SUBDIVISION REVIEW SHEET

CASE NO.: C8-2022-0267.0A

SUBDIVISION NAME: Resubdivision of Lot 1-A

**CITY OF AUSTIN –DEVELOPMENT SERVICES DEPARTMENT
SUBDIVISION APPLICATION – MASTER COMMENT REPORT**

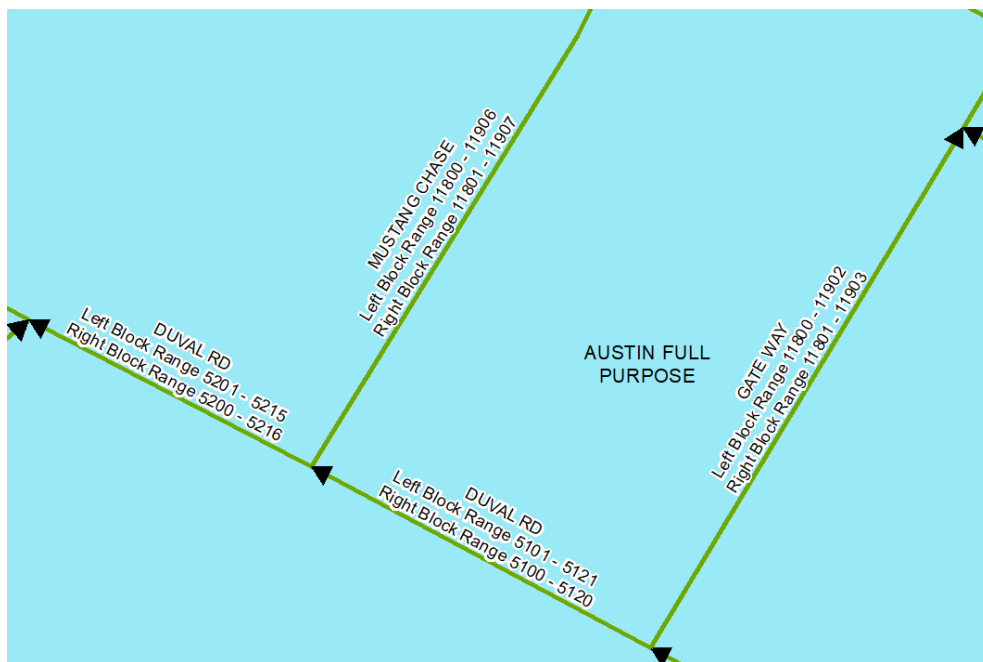
AD1: This plat review is Rejected;

AD2: GATE WAY is the correct street name for this project

NOTE1: GATE WAY (two words) is incorrectly labeled as GATEWAY (one word) on location map.

Zoomed in Wetland CEFs:

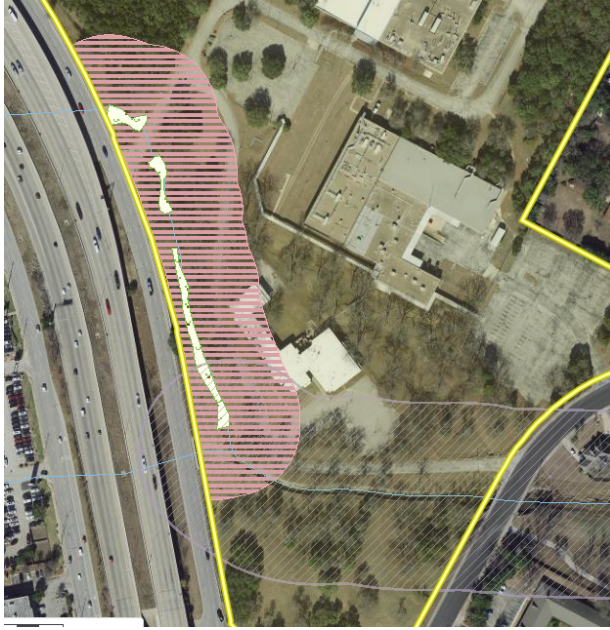
FYI Three wetland CEFs (BRG IDs 207775, 207776 and 207777) were previously identified and field verified by WPD staff. These three CEFs coincide with the wetland CEFs identified in the ERI conducted by Terracon (dated July 2019). Please the screenshots of the approximate location and boundaries of the wetland CEFs on Property Profile Tool. In addition, the Shapefiles for the wetland CEFs are available on Property Profile to be downloaded.

WB1. Update0. Please demonstrate compliance with LDC 25-8-281 or 30-5-281; LDC 25-8-282 or LDC 30-5-282.

Additional information: {This reviewer cannot establish wetland CEF protection provisions. e.g. Clearly show the boundary of the wetland CEFs and clearly label the features: "WETLAND CEF" on all plat sheets where they exist. Please show the wetlands as shown in the Environmental Resource Inventory and on Property Profile Tool see screenshots above.}

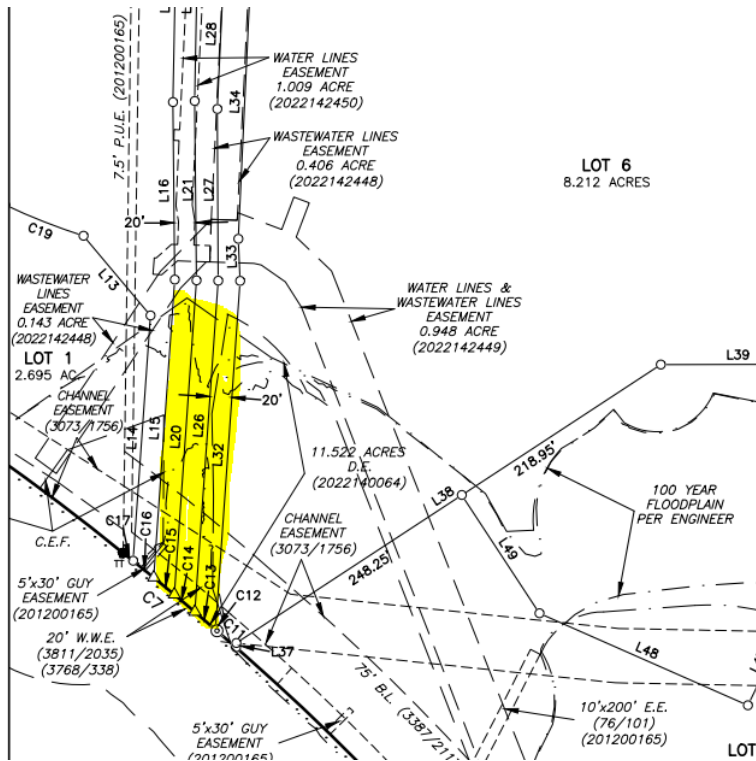
Update1. Repeat comment.

- a) Clearly show and label the wetland CEFs as stated above.
- b) Remove the modified wetland CEF setback from the plat.
- c) The proposed water and wastewater line easements (highlighted in yellow in the screenshot below) appear to be bisecting/crossing one of the wetland CEFs. If this is accurate, the encroachment of these easements was not incorporated in the approved wetland CEF mitigation plan for SP-2021-0108D and additional 1:1 mitigation pursuant to ECM 1.10.4 will be required for this additional encroachment/impact to the wetland CEF and associate CEF setback.
